Access Compliance Report

Public Rights-of-Way

(Curb Ramps)

Intersection ID: 43349	Main Street: FORESTRIDGE COMMONS DR	Cross Street: PROSPERITY COMMONS DR	Location: NW
ADA ID: 7A49532C18B2	Ramp Type: PerpDiag	Initial Pass/Fail: Fail	Overall Compliance: No
Codes/Mitigation Info/Possible Solution			Severity Score: 30
			Field Measurements/Component Compliance

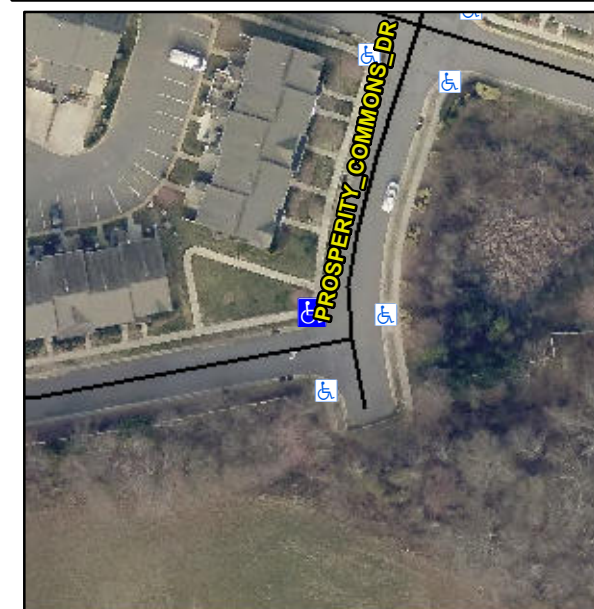
Compliance	Description	Data	Compliance	Description	Data
N/A	Ramp Length (in)	47.0	No	Ramp Slope (%)	11.5
No	Ramp Width (in)	35.0	Yes	Ramp XSlope (%)	1.9
N/A	Flare Type LT	N/A	N/A	Flare Type RT	N/A
N/A	Flare Slope LT (%)	N/A	N/A	Flare Slope RT (%)	N/A
N/A	Flare Traversable LT?	N/A	N/A	Flare Traversable RT?	N/A
N/A	Landing Length (in)	N/A	N/A	DWS Provided?	N/A
N/A	Landing Width (in)	N/A	N/A	DWS Contrast?	N/A
N/A	Landing Slope (%)	N/A	N/A	DWS Length (in)	N/A
N/A	Landing X Slope (%)	N/A	N/A	DWS Full Width?	N/A
N/A	Landing Curb? (Y/N)	N/A	N/A	DWS Offset (in)	N/A
N/A	Shared Landing?	N/A			
N/A	Gutter Ponding?	N/A	N/A	Gutter Slope (%)	N/A
N/A	Gutter Lip Ht (in)	N/A	N/A	Gutter X Slope (%)	N/A
N/A	Painted X Walk1?	No	N/A	Painted X Walk2?	No
	X Walk 1 Direction	To S		X Walk 2 Direction	To E
N/A	X Walk 1 Width (in)	N/A	N/A	X Walk 2 Width (in)	N/A
	X Walk 1 Slope (%)	1.6		X Walk 2 Slope (%)	0.0
	X Walk 1 X Slope (%)	1.1		X Walk 2 X Slope (%)	2.0

Remove & Replace Curb Ramp With Two New Directional Ramps or Equivalent.
